BIDDERS BULLETIN

PROJECT: Bertrand Public Schools – 2013 Library Renovation
Bertrand, Nebraska

BB-1

DATE ISSUED: March 6, 2013

DATE: March 6th, 2013
DRAWING: A102-1
FROM SHEET: A102

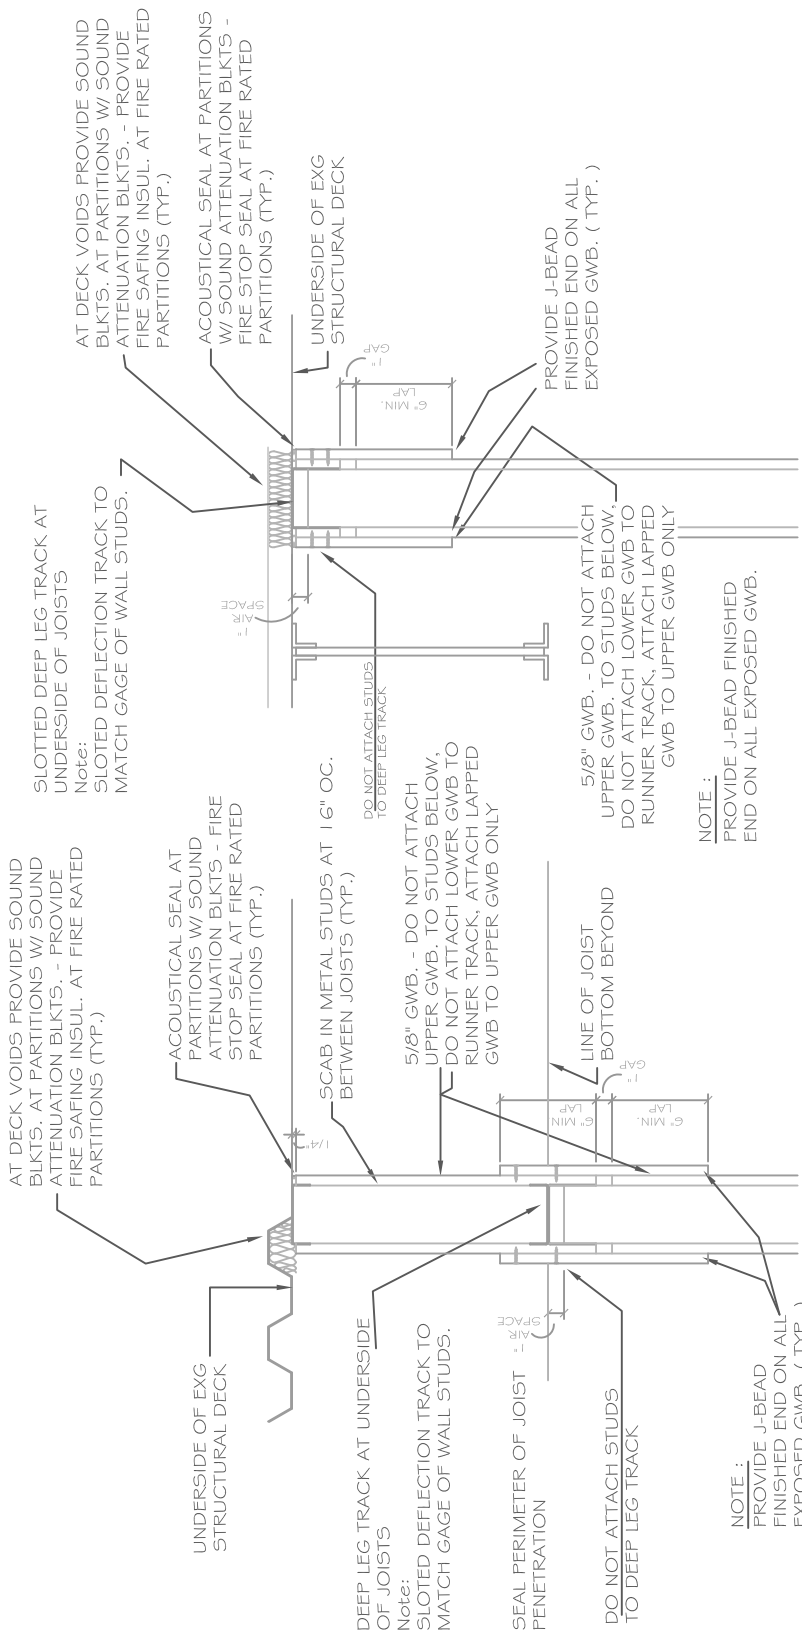
5. At detail D5/A102 add a note to read: "SIMILAR-1 CONDITION: Use 8" CMU end wall cap with bullnose corner, anchor to existing masonry at 16" o.c., extend to existing roof deck and fire caulk joints, paint to match existing."
6. At detail D5/A102 revise the note to read: "NOTE: Coordinate new infill coursing with existing conditions and extend new CMU up to existing metal roof deck."
7. Include wall details D18/A102 for rated walls from the attached sheet A102-1.
8. Include wall details D19/A102 and the revised AL-1 aluminum frame from the attached sheet A102-2.
